Planning Commission Report

Project Type:	Site Development Section Plan
Meeting Date:	May 11, 2020
From:	Annisa Kumerow, Planner AK
Location:	North side of Chesterfield Airport Road and east of Long Road
Description:	<u>TSG Chesterfield Airport Road, Lot A (Jaguar Land Rover):</u> A Site Development Section Plan, Landscape Plan, Mitigation Plan, Lighting Plan, Architectural Elevations and Architect's Statement of Design for an 8.728 acre tract of land zoned "PC" Planned Commercial District located north of Chesterfield Airport Road and east of Long Road.

Re: TSG Chesterfield Airport Road, Lot 1 SDSP (Jaguar Land Rover) – Response Letter
(Stock Project No. (218-6407.4))

Figure 8: North elevation

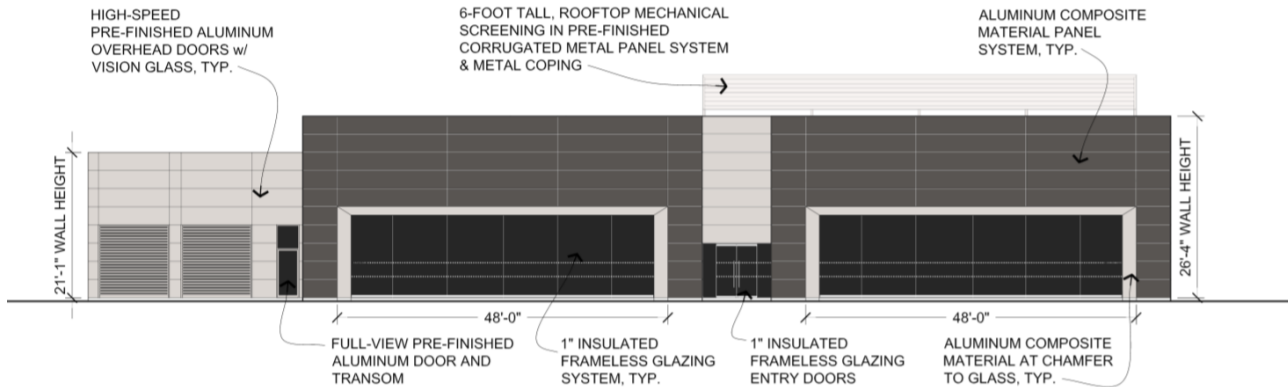
Two aluminum service doors are proposed on the north elevation, and will be visible from I-64/US-40. I-64 is a highly trafficked roadway and any elements along the north elevation, including the aluminum service doors, will be highly visible to motorists on the interstate. A higher quality door has been proposed to address the architectural design element.

Figure 9: West Elevation

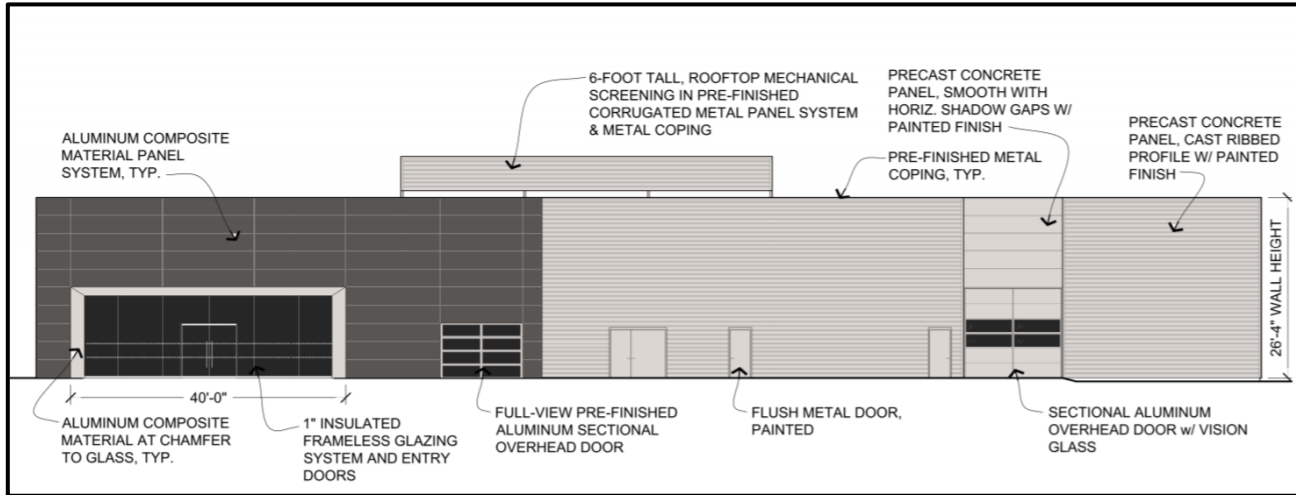
The applicant has incorporated two improvements to the project since the Architectural Review Board Meeting. The first change is the elimination of the corrugated aluminum panels on all elevations, with the exception of the rooftop screening unit. The corrugated aluminum panels have been replaced with precast concrete panels. The second change is the addition of corrugated aluminum panels in a smooth painted finish over the service door on the west elevation. However, these changes have not met the full extent of the Architectural Review Board’s intention, specifically regarding the concept of a four sided building that has equal attractiveness of architectural elements on all facades, and how it relates to the west elevation. Additionally, Unified Development Code § 31-04-01D.2.(a) states that all structures should “design and coordinate all facades with regard to color, types and numbers of materials, architectural form and detailing”. Furthermore, Chesterfield Valley Policy 1 states that “care should be taken to make sure that any portion of a building is equally uniform in materials and attractiveness as the primary façade.” In comparison to

the other elevations, the west elevation does not reflect the concept of a four sided building with equal attractiveness on all sides.

SOUTH ELEVATION

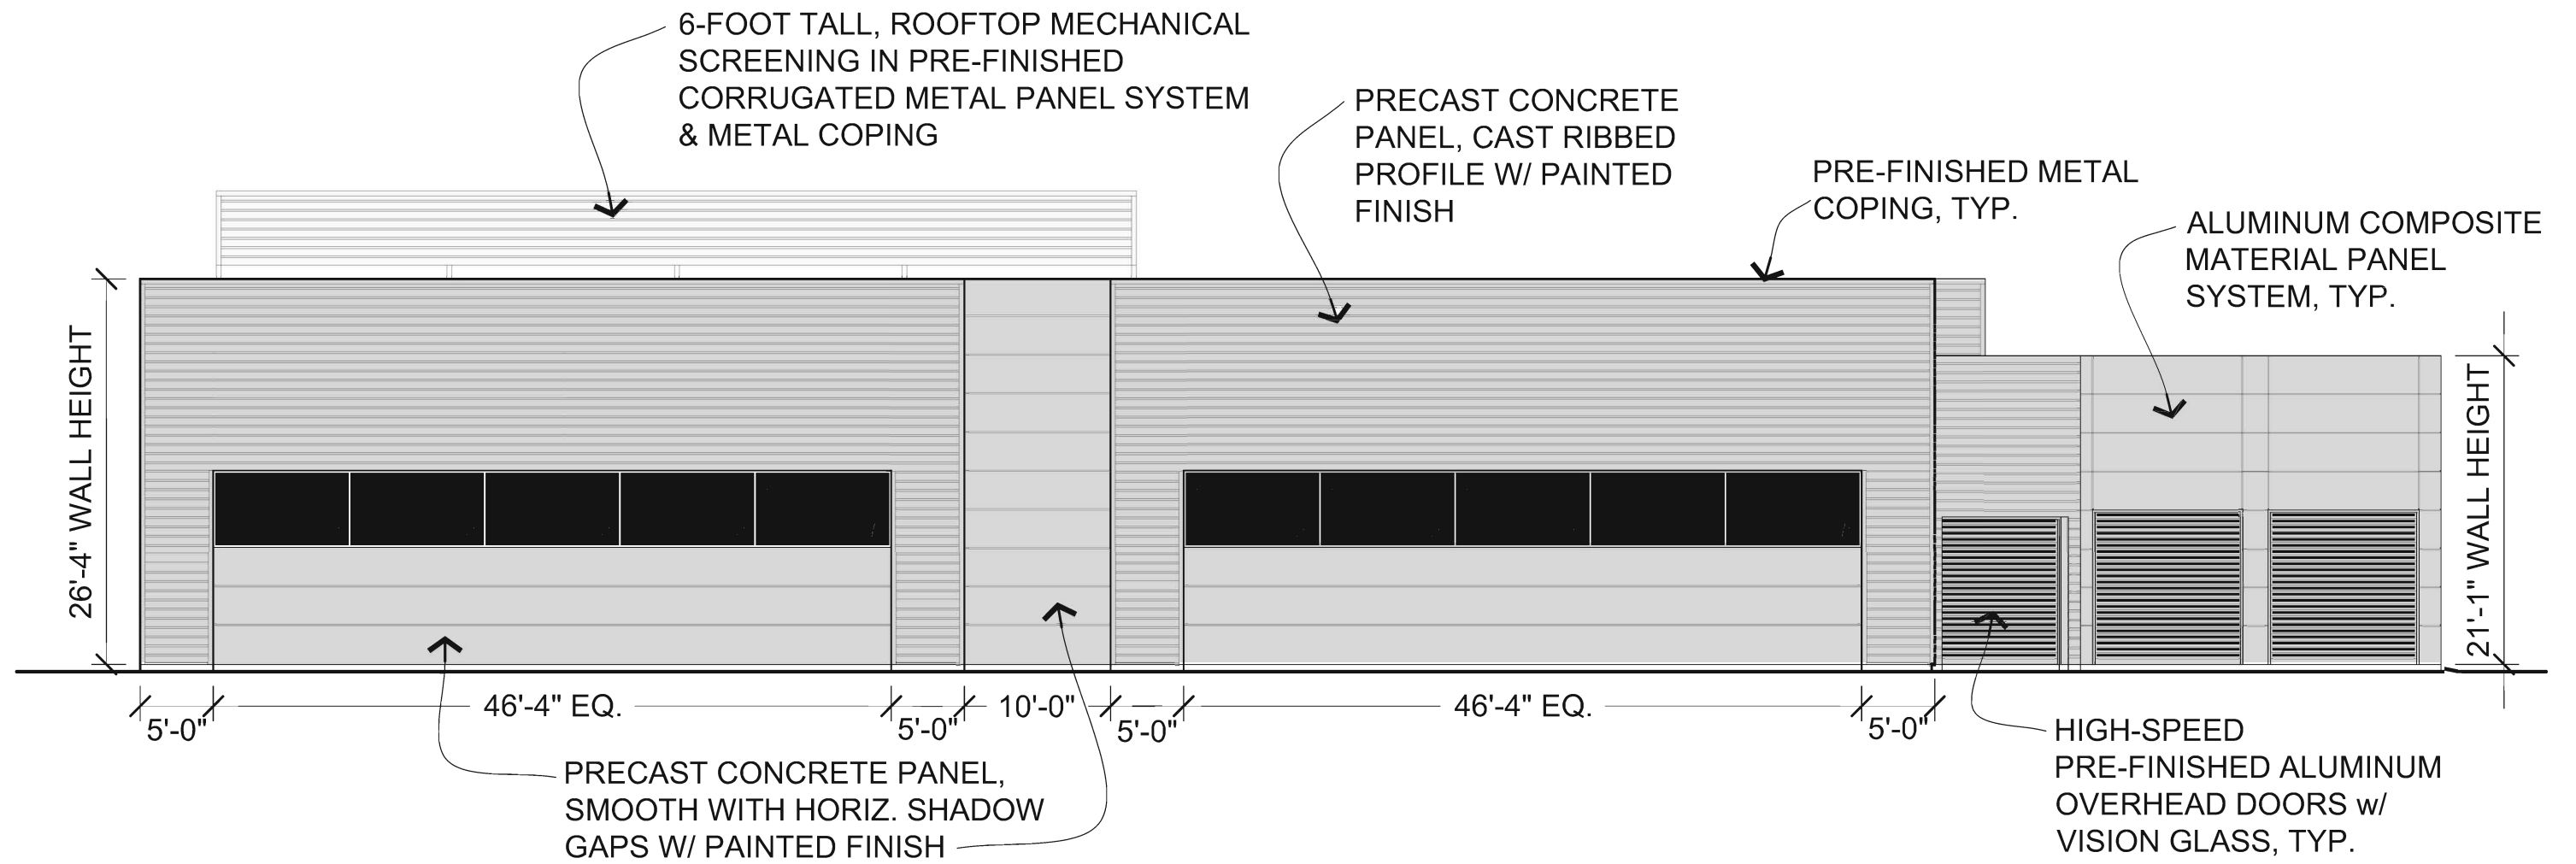
2. The South elevation depicts two triangles that are not called out on the elevations. For reference, see the image below. Revise the elevation as necessary to include a call out for this item.

Response: The triangles referenced and as seen on the South Elevation are pyramidal skylights above the service department. The Owner has opted to remove these skylights since there have been windows added to the South Elevation. This change is reflected within the enclosed submittal.

WEST ELEVATION

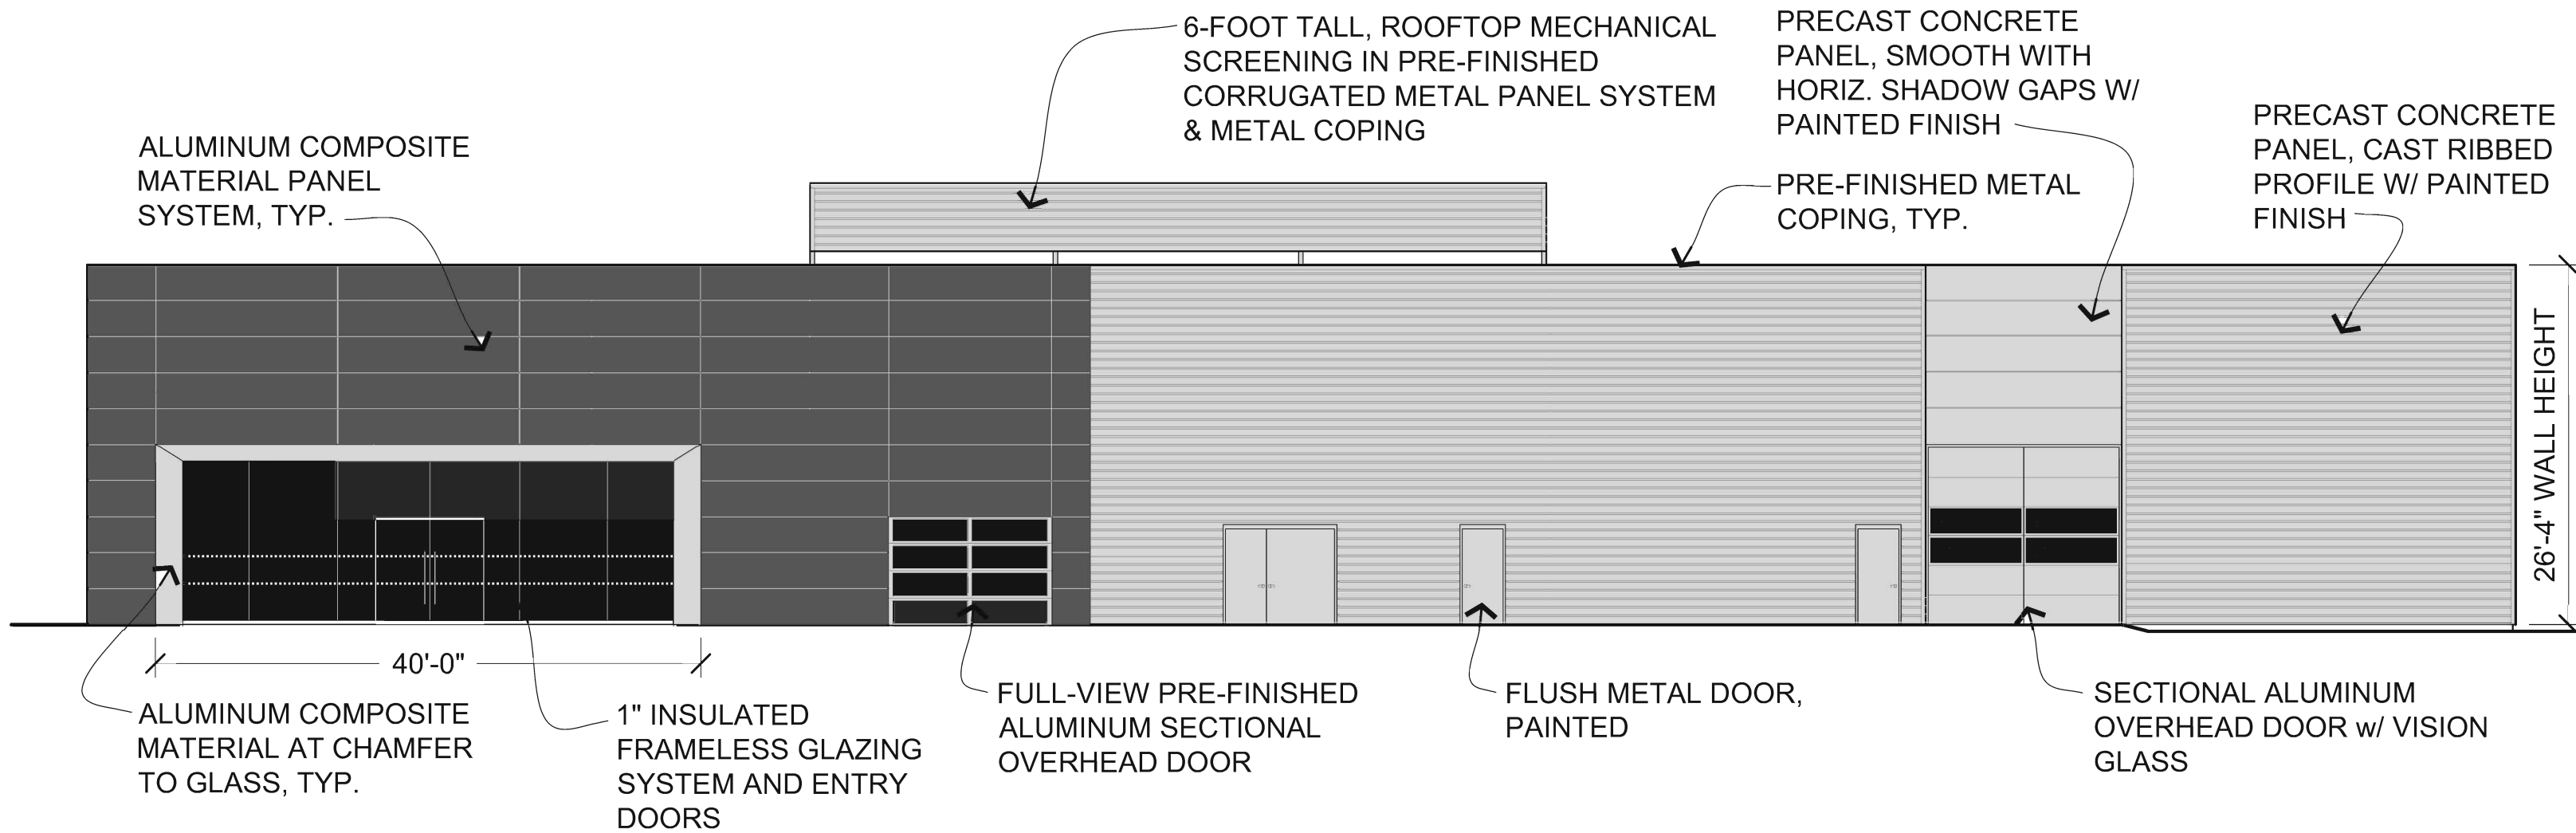
1. The Architectural Review Board recommended approval with conditions on March 12th, 2020. The recommendations were as follows:
 - o To further enhance the concept of a four-sided building that has equal attractiveness of architectural elements on the front façade (show room) with the sides and rear (service area).
 - o Introduce a higher quality material, possibly the concrete tilt up panel vs. the corrugated metal as a primary material

In order to meet the Architectural Review Board's recommendation, revise the west elevation as necessary to create a more uniform and integrated elevation.

Response: The west elevation has gone through two changes since the last submittal. The first is a change to the exterior materials. The areas previously clad in corrugated metal panels have been revised to architectural precast concrete. The corrugated metal panels have been eliminated from the facades of all sides of the building and only remain at the rooftop mechanical screen walls. The second change is revising the architectural precast panels above the service door to a smooth finish painted to match the aluminum composite panels that are above the Front Entry on the North elevation. These changes have been negotiated and approved via Jaguar Land Rover corporate procedures. Additional changes will most likely not be approved by Jaguar Land Rover.
